Re: AFC Urgent Care (#1491141)/Pre-Application Meeting held October 08, 2020

STAFF COMMENTS - PRE-APPLICATION MEETING

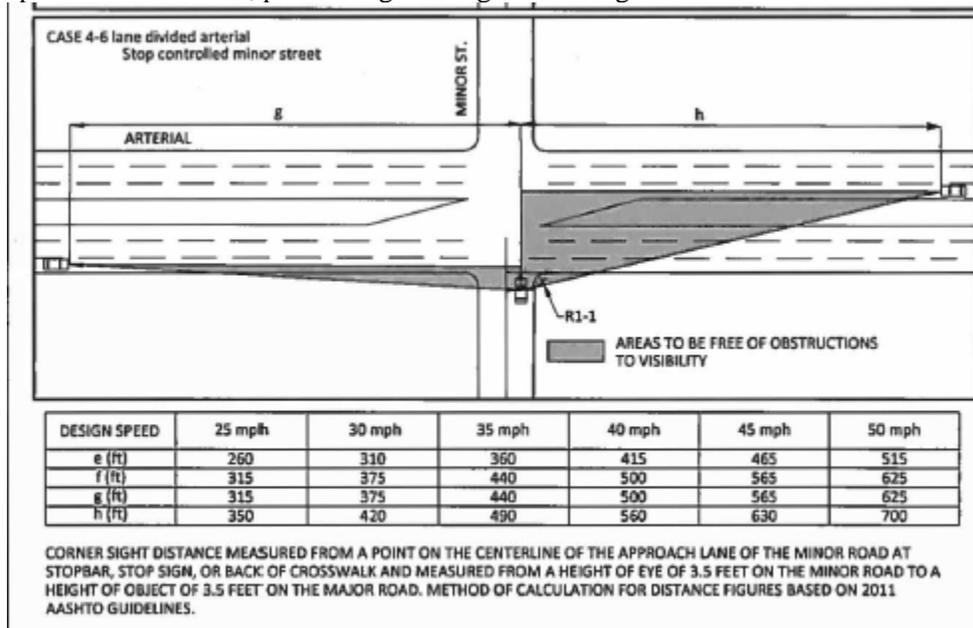
Key Issues:

- ▶ A Detailed Traffic Impact Study will be required with this development. See below for additional information.
 - Discussion of Urgent Care using ½ of the square footage, other ½ would be either a different medical use or coffee shop.

- Based on the size of this lot, layout and proximity to Colfax Avenue, Traffic Engineering does not support a coffee shop drive thru.
- ▶ Colfax Avenue is a state highway. Approval and access permits will need to be obtained from the Colorado Department of Transportation (CDOT). Please contact *Marilyn Cross* at CDOT, phone number 303.512.4266. Developers/applicants are encouraged to contact CDOT early in the review process to determine the feasibility of the proposed access and any specific CDOT requirements. In order to insure CDOT will allow access as shown, provide a letter from CDOT indicating they have reviewed the proposed access(es). **This email/letter must be received 10 days prior to the Planning Commission hearing.**

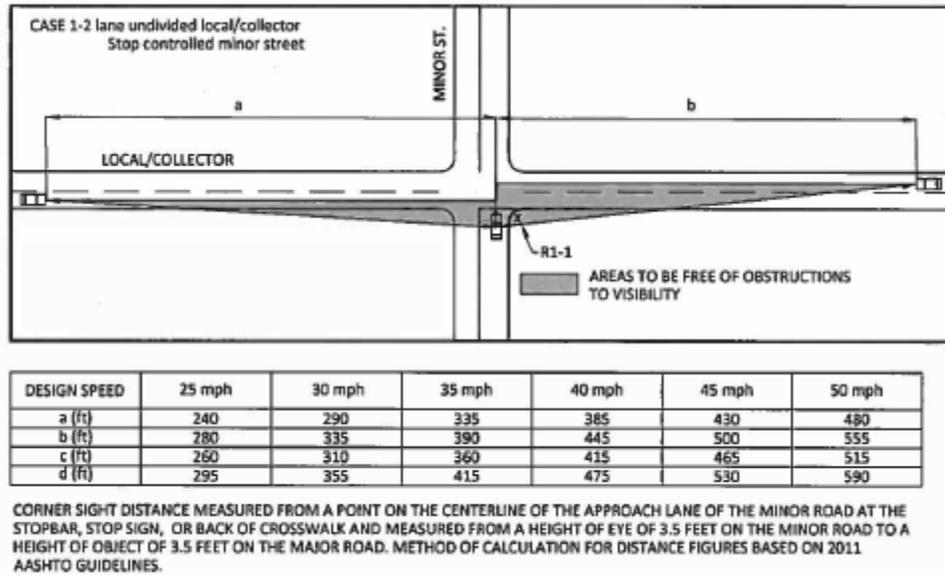
- Design Speed of Colfax Avenue is 50mph. Colfax Avenue has the width to potentially be restriped for 3-thru lanes, provide sight triangle assuming 3-thru lanes.
